DESIGN RESPONSE

20009DA

104-116 REGENT STREET
REDFERN

09 JUN, 22

FIGURE 7. ORIGINAL PROPOSAL

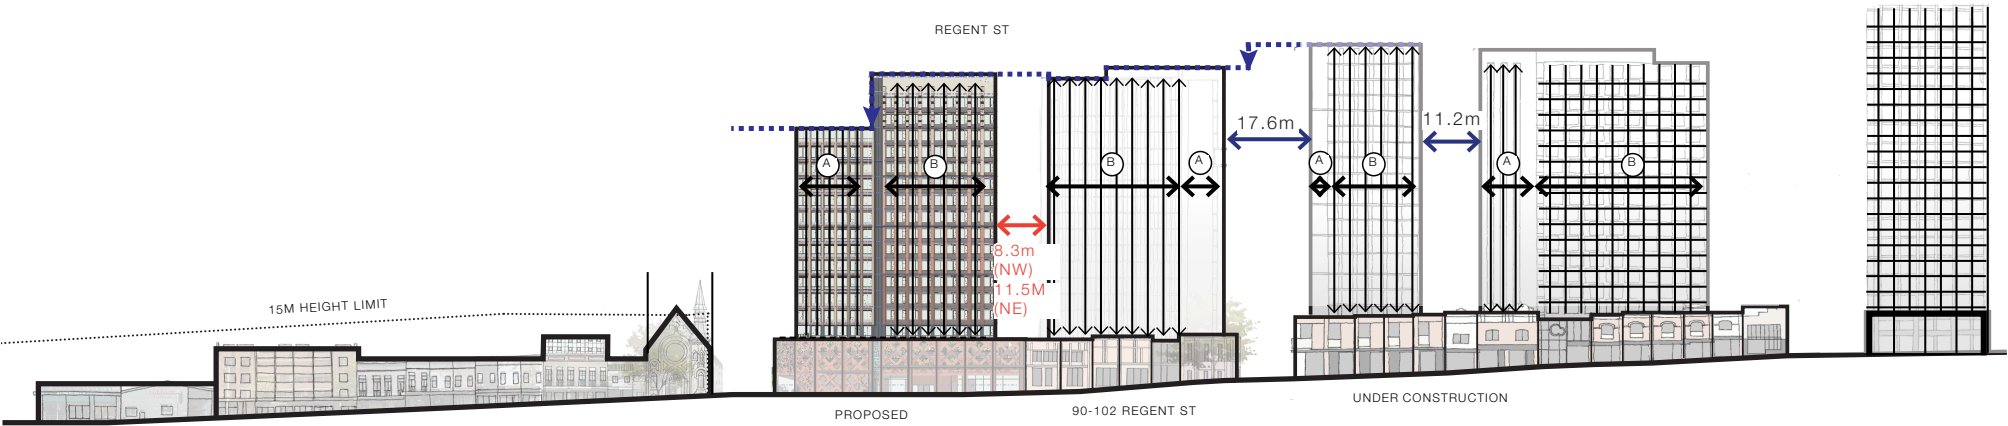
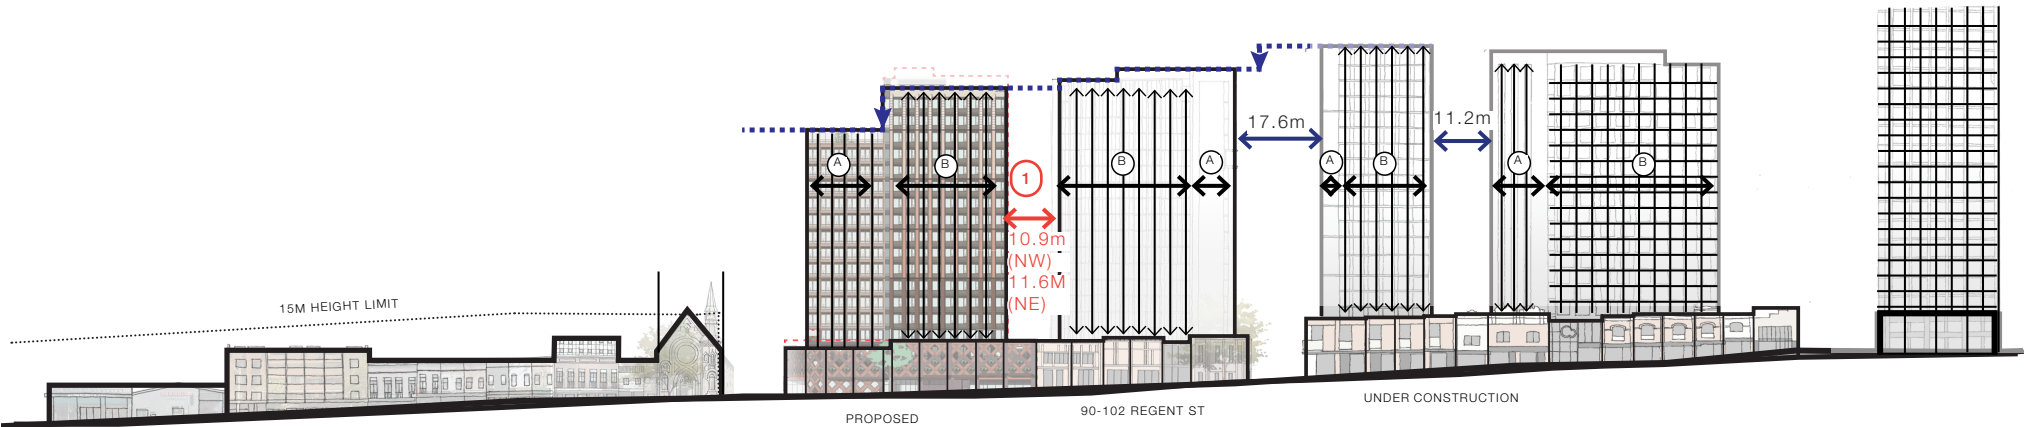
- Increase the podium separation along the western boundary between the proposed development and 13-23 Gibbons Street
- Increase the tower separation along the northern boundary between the proposed development and 90-102 Regent Street.

The tower separation to the north and west do not respond to the recommendations of the RCUDP. The development relies on the building setbacks of neighbouring developments to achieve tower separation. The proposed tower setbacks result in inadequate spacing between buildings in the streetscape, results in loss of view sharing, privacy and acoustic amenity impacts and is not supported by the City.

Specifically, a 9-metre setback is outlined in the RCDP to achieve an 18- metre building separation between developments. At the north-west corner, a party wall condition is proposed with a 0.3m distance from the northern boundary increasing to 4.1m at the north-east. This is the most non-compliant tower separation proposed of the 4 towers on neighbouring sites located within this respective block. The fundamental tower massing strategy was a matter consistently raised by the State Design Review Panel as being inadequately investigated and proves to be the case in the EIS.

Further the revised design proposal has achieved 2.65m set back at the north-west and 4.2m at the north-east, resulting in circa 11m separation from the neighbouring tower. The outcome is considered appropriate when considering other tower separation along Regent streetscape ranging from 11.2m - 17.6m (refer figure 6 -8 showing building separation)

① Streetscape Tower separation increased

FIGURE 9. NORTH FACADE - PRIVACY LOUVRES - VIEW ANALYSIS

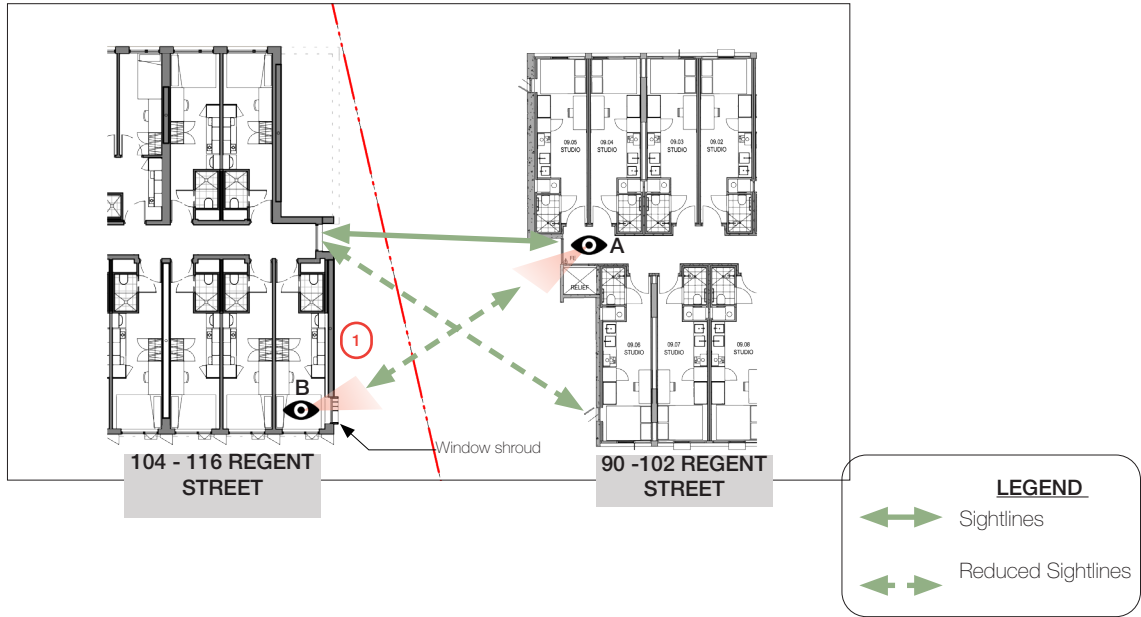
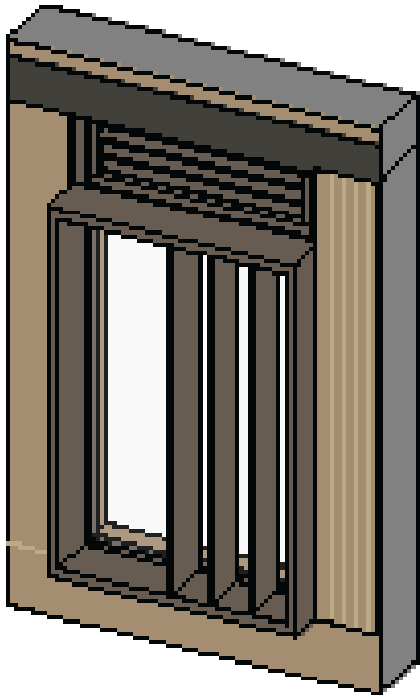
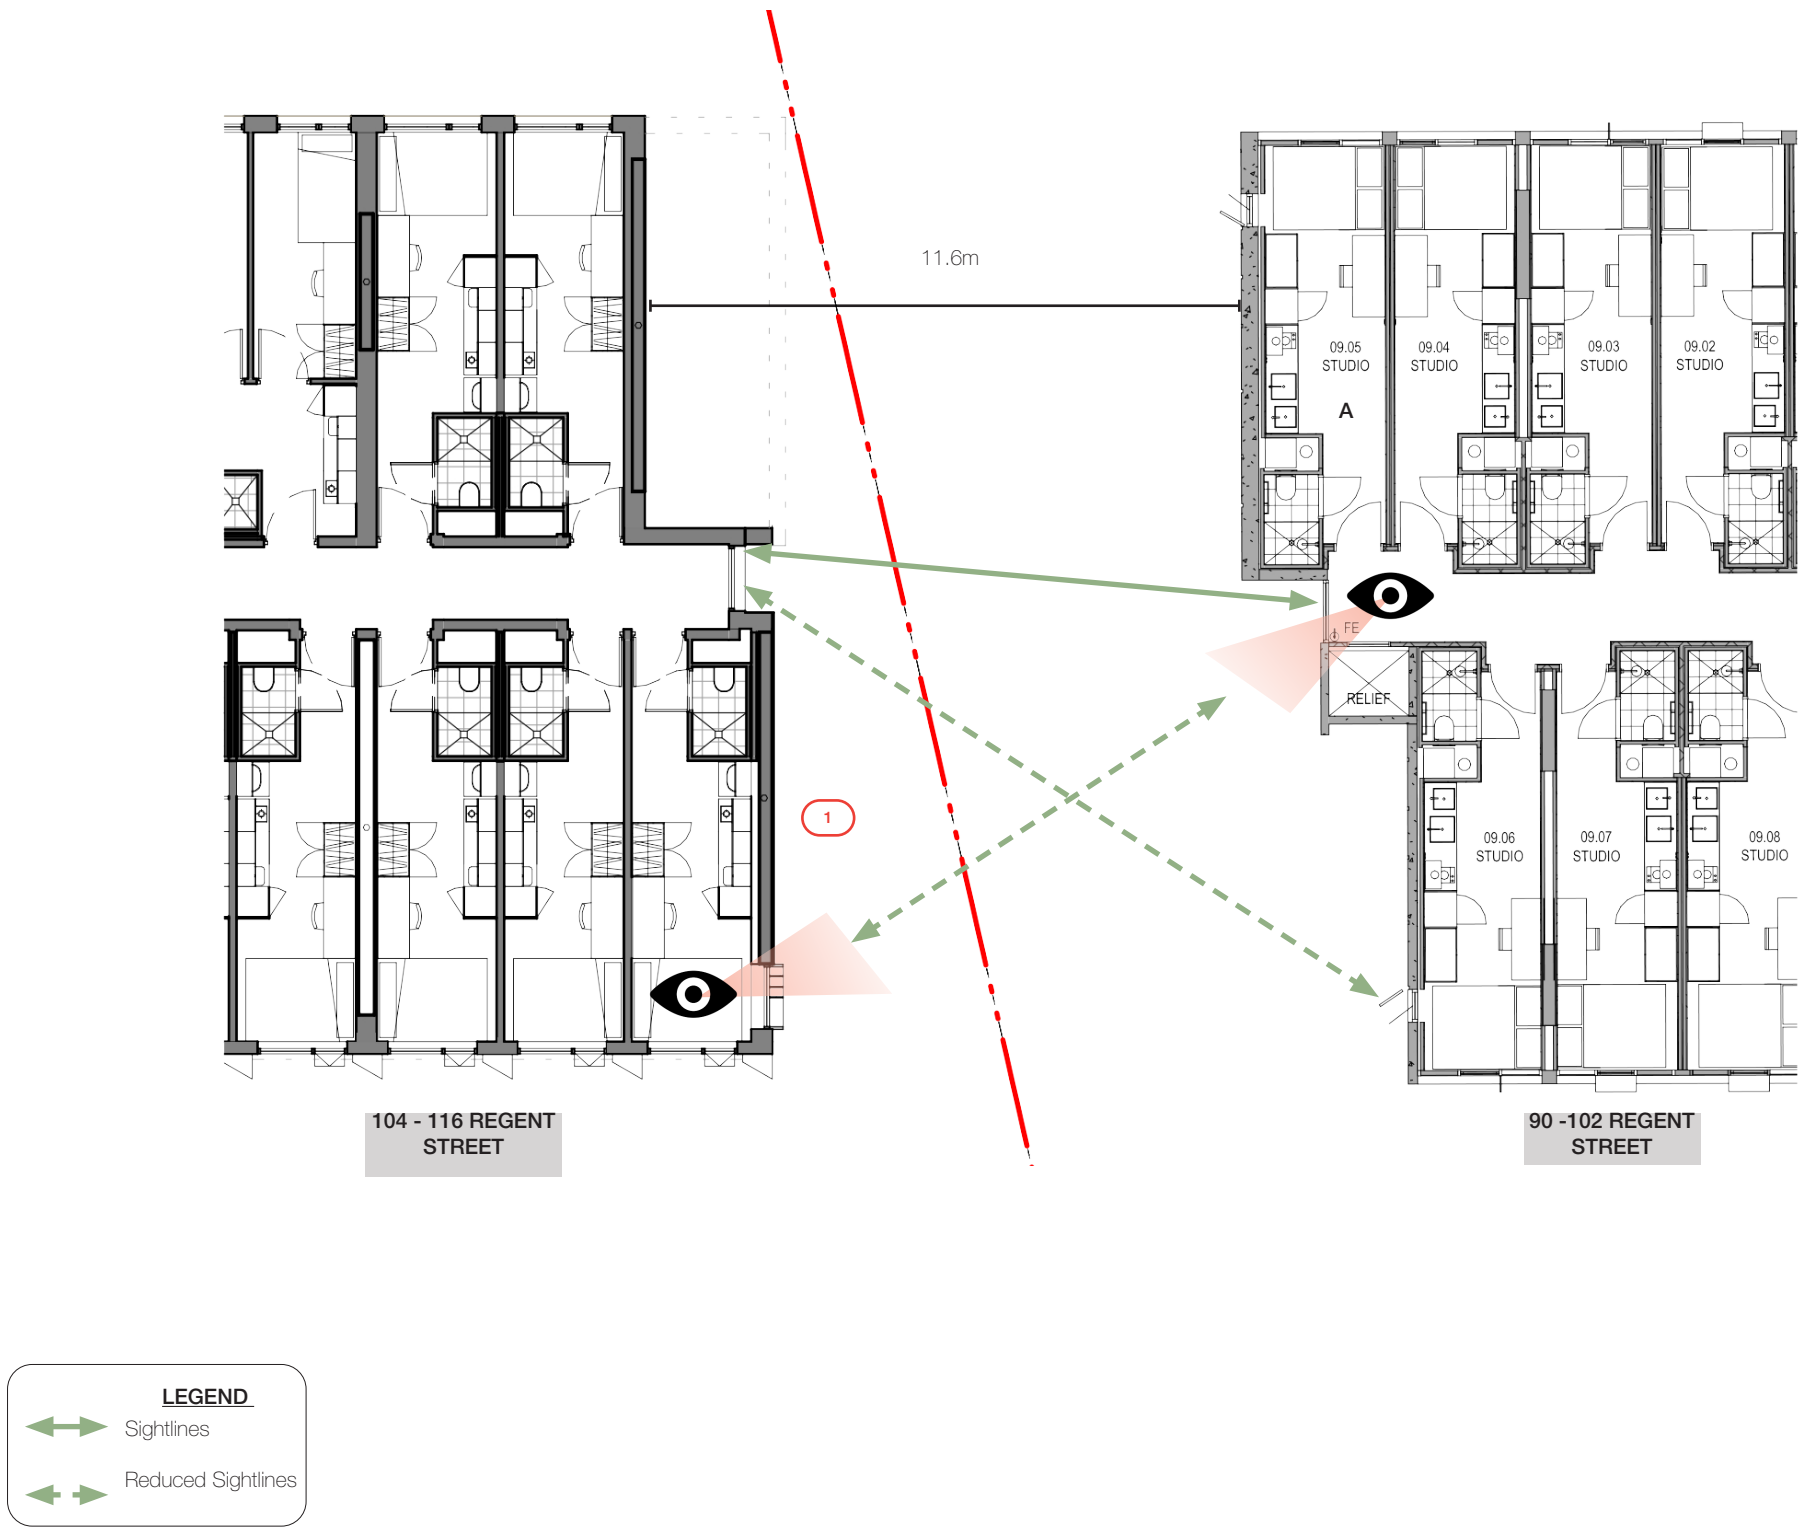
- Install appropriate privacy treatments within the northern and western elevations of the proposal

- Install fixed external privacy treatments to north facing corridor windows
- Install operable external privacy treatments to west facing rooms opposite 13-23 Gibbons Street

The redesign has suitably addressed improvement of visual privacy to 90-102 Regent Street with below changes. (Refer figures 9 - 11 for view analysis and treatment)

- One Corner window at the north west being removed.
- However the retained corner window at the north-east allows articulation to the the part of North facade visible when travelling down the Regent Street.
- Further, external privacy screen to this north- east window for privacy to the habitable space looking out from the corridor of 90-102 Regent Street.

- ① External privacy louvers installed to North facing bedrooms opposite 90-102 Regent st

FIGURE 15 -1 MARGARET ST - OVERSHADOWING

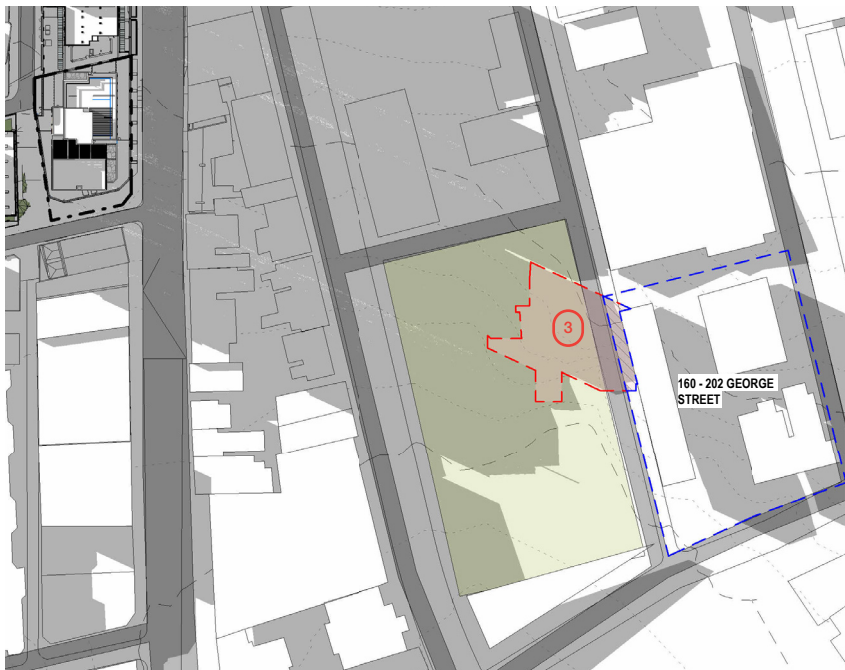
The overshadowing analysis confirms that the proposal would cast a large shadow over properties to the southwest, south and southeast in mid-winter. The analysis does not consider the specifics of any overshadowing on individual properties nor does it capture the full extent of the overshadowing impacts with cropped shadow plans omitting the full shadow extent.

The impact must be quantified, in terms of both the measurable criteria in the RCUDP controls, and any impacts justified of particular concern is the impact to 1 Margaret Street and the playing field at National Centre of Indigenous Excellence at 160-202 George Street.

Additional information, which quantifies resulting solar access, the overshadowing impact, and adequate justification is required for these sites in half hourly views from the sun.

- 1 Additional overshadowing from amended proposal has minimal impact on 1 Margaret street overshadows only at 9am on 21 June
- 2 Additional overshadowing from amended proposal overshadows the field starting overshadows only at 2:30pm
- 3 Additional overshadowing from amended proposal overshadows 160-202 George Street starting at 2:30pm

Additional information of half hourly views provided with extended view to capture the south east shadowing. Refer architectural drawings DA 6.02 and DA 6.03 (refer appendix on pages 22 & 23). The proposed built form has been designed to avoid unacceptable shadow impacts to surrounding developments and public domain.

- Additional overshadowing from amended proposal has minimal impact on 1 Margaret Street , overshadows only small corner area on the south eastern corner outlined in blue (refer to figure15)
- Additional overshadowing from amended proposal overshadows a portion of the playing field at National Centre of Indigenous Excellence only between 2.30 -3.00pm

FIGURE 18 - LEVEL 1 - FIRE BOOSTER INTEGRATION

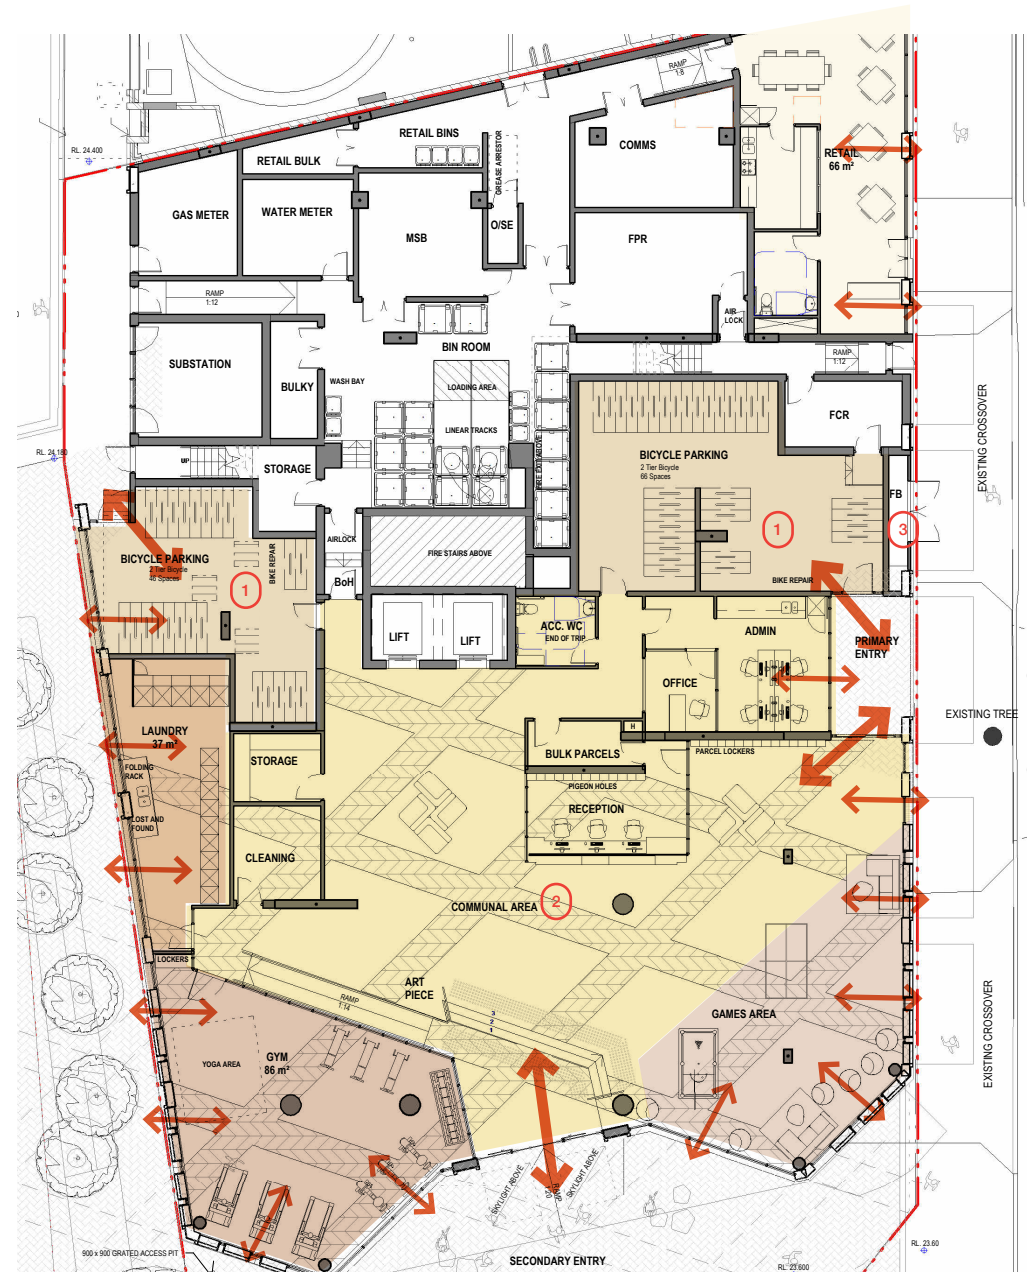
The proposed development has frontages to Regent and Margaret Streets as well as the future through site link and provides opportunities for street activation. However, the development does not provide a genuine active frontage with good levels of passive surveillance. The Regent Street entry provides minimal passive surveillance as a result of the location of the bicycle parking facilities that occupy the majority of frontage. It presents areas of concealment with Crime Prevention Through Environmental Design (CPTED) concerns for both residents and the public.

A small area of retail is located on the north-east corner. It provides a 3.8 metre floor to floor height and 2.8-metre-high window, which presents a more residential scale than commercial and does not maximise a genuine active frontage. A large fire booster cabinet is provided on the Regent Street elevation and does not adequately integrate with the façade. The Margaret Street facade includes a recessed secondary entry, which sits in an under croft of the podium. This fails to positively reinforce the street edge, would receive no natural light due to its orientation, and creates CPTED concerns for both residents and the public. The though site link facade also includes large areas of services with no entry point for activation.

The City recommends that these street frontages be redesigned to create safe and welcoming entrances with good passive surveillance, which positively contributes to the street. A more generous provision of retail area to the Regent Street frontage is also encouraged to increase genuine activation with increased floor to floor heights and glazing.

The bicycle parking has been split to allow access from both William land and Regent St. This maximizes the active frontage(refer to figure 17) The redesign includes relocation of Administration/ Office to occupy the frontage. The Games area has been relocated on the Ground level for further activation of the communal area on ground floor, whilst the study rooms have been relocated to the quieter level 02.

In addressing CPTED concerns the ground floor layout has been reconfigured to mitigate any area of concealment around the bicycle parking entry (refer to figure 17)

Fire booster cupboard finish has considered the quality of facade treatment with metal claddded tongue and groove pattern on the door (refer figure 18)

- 1 Bike parking reconfiguration and split in two
- 2 Internal spaces reprogramming - Office and Games for enhanced visual interface and activation
- 3 Metal cladding treatment to fire booster cupboard to intergrate with quality of facade
